Westinghouse Non-Proprietary Class 3

Attachment 2

RAI Responses for WCAP-17661-P/ WCAP-17661-NP, Revision 1

Figure RAI-6.1 Comparison of Predicted Trend in $F_Q^C(Z)$ or $F_Q^W(Z)$ as a Function of Cycle Burnup for an Example Plant

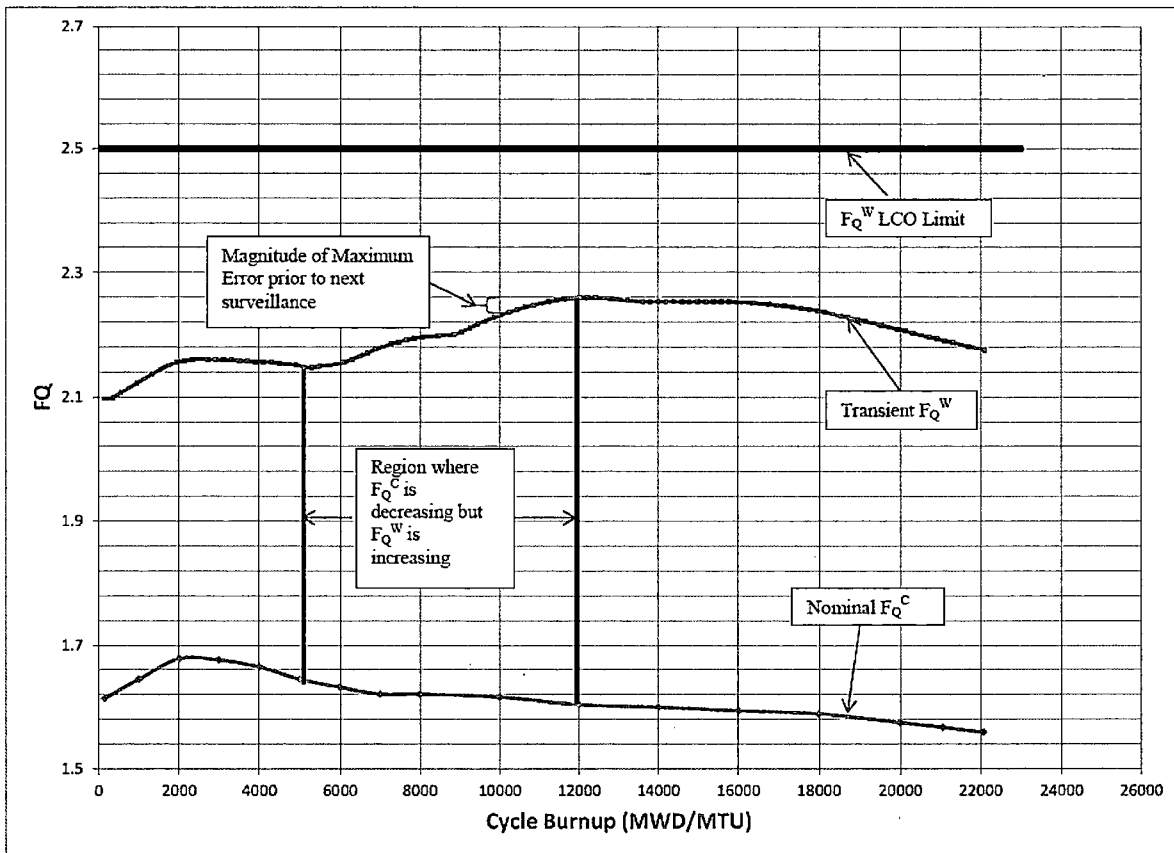
- a. Explain how this would actually take place.
- b. Provide data from past experience and additional discussion supporting the statement "past measurement trends of $F_Q^C(Z)/K(Z)$ may or may not be indicative of future margin trends."

An issue has been identified that the use of measured trends in $F_Q^C(Z)$ may not always be indicative of the same margin trend in the measured $F_Q^W(Z)$, particularly when the axial power distribution of the core is in transition from a cosine type shape to a flattened saddle type shape. Figure RAI-6.1 illustrates an example of such a case by comparing the predicted steady state and maximum transient F_Q values for an example cycle.

Furthermore, it must be clarified that the initial onset of CIPS will not necessarily result in observing a decreasing trend in either the $F_Q^C(Z)$ or $F_Q^W(Z)$ margin. The preferential accumulation of boron-containing crud in high power assemblies will tend to decrease the radial peaking ($F_{XY}(Z)$) in the affected elevations of the highest power assemblies. If the nominal predicted AFD is slightly positive, the onset of CIPS may result in the AFD being closer to zero or slightly negative. Both of these factors could result in an increasing trend in margin for $F_Q^C(Z)$, initially. The trend in $F_Q^W(Z)$ is driven largely by the $T(Z)$ or $W(Z)$ surveillance factors, which, as noted in Section 4.5 of WCAP-17661-P, will not include the effects of CIPS if it occurs. Thus, the observation of past trends in margin for either $F_Q^C(Z)$ or $F_Q^W(Z)$ is not very useful in identifying the onset of CIPS. Only in the later stages of a relatively severe CIPS event can it be stated with high confidence that the $F_Q^C(Z)$ margin will be decreasing with burnup.
